# Access Compliance Report

## Public Rights-of-Way

Intersection ID: 17032	Main Street: QUEENS_RD_WEST	Cross Street: WESTFIELD_RD	Location: SE
ADA ID: C1A8CF8772C2	Ramp Type: Perp	Initial Pass/Fail: Fail	Overall Compliance: No
Severity Score: 26.25			
Codes/Mitigation Info/Possible Solution		Field Measurements/Component Compliance

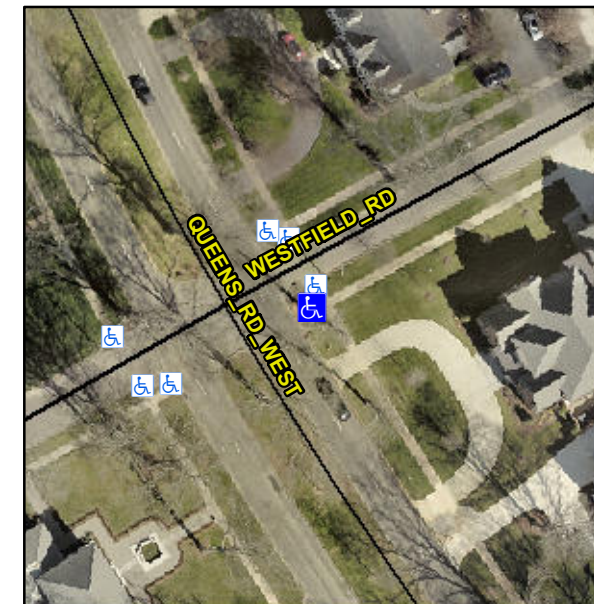
**Remove & Replace Entire Ramp.**

**R304.2.2, R304.5.3**

Compliance	Description	Data	Compliance	Description	Data
N/A	Ramp Length (in)	53.0	No	Ramp Slope (%)	12.5
Yes	Ramp Width (in)	65.0	No	Ramp XSlope (%)	3.7
N/A	Flare Type LT	N/A	N/A	Flare Type RT	N/A
N/A	Flare Slope LT (%)	N/A	N/A	Flare Slope RT (%)	N/A
N/A	Flare Traversable LT?	N/A	N/A	Flare Traversable RT?	N/A
N/A	Landing Length (in)	N/A	N/A	DWS Provided?	N/A
N/A	Landing Width (in)	N/A	N/A	DWS Contrast?	N/A
N/A	Landing Slope (%)	N/A	N/A	DWS Length (in)	N/A
N/A	Landing X Slope (%)	N/A	N/A	DWS Full Width?	N/A
N/A	Landing Curb? (Y/N)	N/A	N/A	DWS Offset (in)	N/A
N/A	Shared Landing?	N/A			
N/A	Gutter Ponding?	N/A	N/A	Gutter Slope (%)	N/A
N/A	Gutter Lip Ht (in)	N/A	N/A	Gutter X Slope (%)	N/A
N/A	Painted X Walk1?	No	N/A	Painted X Walk2?	N/A
	X Walk 1 Direction	To SW		X Walk 2 Direction	N/A
N/A	X Walk 1 Width (in)	N/A	N/A	X Walk 2 Width (in)	N/A
	X Walk 1 Slope (%)	3.5		X Walk 2 Slope (%)	N/A
	X Walk 1 X Slope (%)	0.5		X Walk 2 X Slope (%)	N/A
